# Access Compliance Report

## Public Rights-of-Way

Intersection ID: 3385	Main Street: BRANDY RIDGE LN	Cross Street: POPLAR GROVE DR	Location:	S
ADA ID: 616B963EAAC7	Ramp Type: Perp	Initial Pass/Fail: Fail	Overall Compliance: No	Severity Score: 10
Codes/Mitigation Info/Possible Solution		Field Measurements/Component Compliance

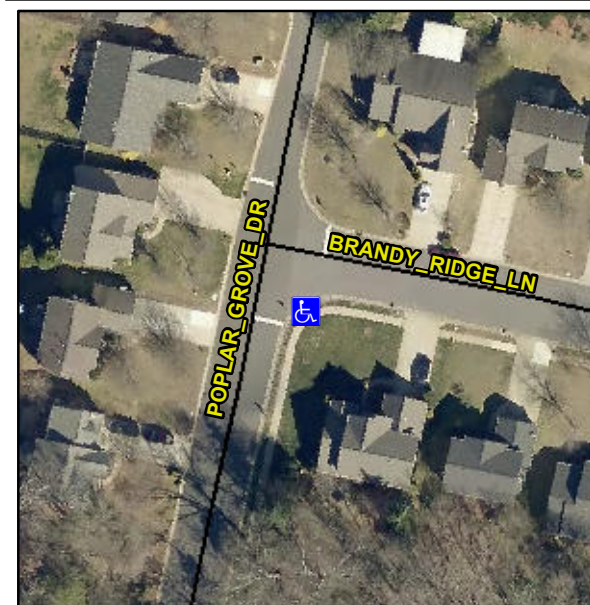
**Remove & Replace Entire Ramp.**

**Not Found, R304.5.1, R304.5.3**
